# Access Compliance Report

## Public Rights-of-Way

### (Curb Ramps)

Intersection ID: 10041994	Main Street: WINDY_VALLEY_DR	Cross Street: N/A	Location: NW
ADA ID: 25F18155FDD8	Ramp Type: Perp	Initial Pass/Fail: Fail	Overall Compliance: No
Severity Score: 10			
Codes/Mitigation Info/Possible Solution		Field Measurements/Component Compliance

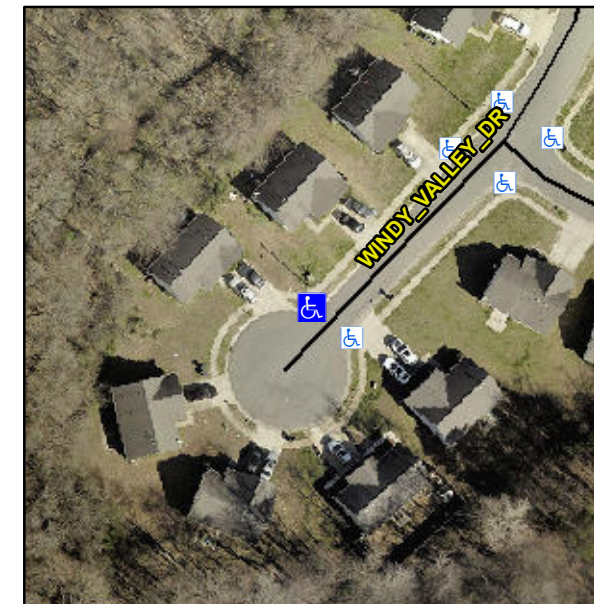
**R304.5.1, R304.5.3**

Compliance	Description	Data	Compliance	Description	Data
N/A	Ramp Length (in)	50.0	Yes	Ramp Slope (%)	7.9
No	Ramp Width (in)	45.0	No	Ramp XSlope (%)	2.1
N/A	Flare Type LT	N/A	N/A	Flare Type RT	N/A
N/A	Flare Slope LT (%)	N/A	N/A	Flare Slope RT (%)	N/A
N/A	Flare Traversable LT?	N/A	N/A	Flare Traversable RT?	N/A
N/A	Landing Length (in)	N/A	N/A	DWS Provided?	N/A
N/A	Landing Width (in)	N/A	N/A	DWS Contrast?	N/A
N/A	Landing Slope (%)	N/A	N/A	DWS Length (in)	N/A
N/A	Landing X Slope (%)	N/A	N/A	DWS Full Width?	N/A
N/A	Landing Curb? (Y/N)	N/A	N/A	DWS Offset (in)	N/A
N/A	Shared Landing?	N/A			
N/A	Gutter Ponding?	N/A	N/A	Gutter Slope (%)	N/A
N/A	Gutter Lip Ht (in)	N/A	N/A	Gutter X Slope (%)	N/A
N/A	Painted X Walk1?	No	N/A	Painted X Walk2?	N/A
	X Walk 1 Direction	To SE		X Walk 2 Direction	N/A
N/A	X Walk 1 Width (in)	N/A	N/A	X Walk 2 Width (in)	N/A
	X Walk 1 Slope (%)	2.9		X Walk 2 Slope (%)	N/A
	X Walk 1 X Slope (%)	0.1		X Walk 2 X Slope (%)	N/A

**Remove & Replace Entire Ramp.**
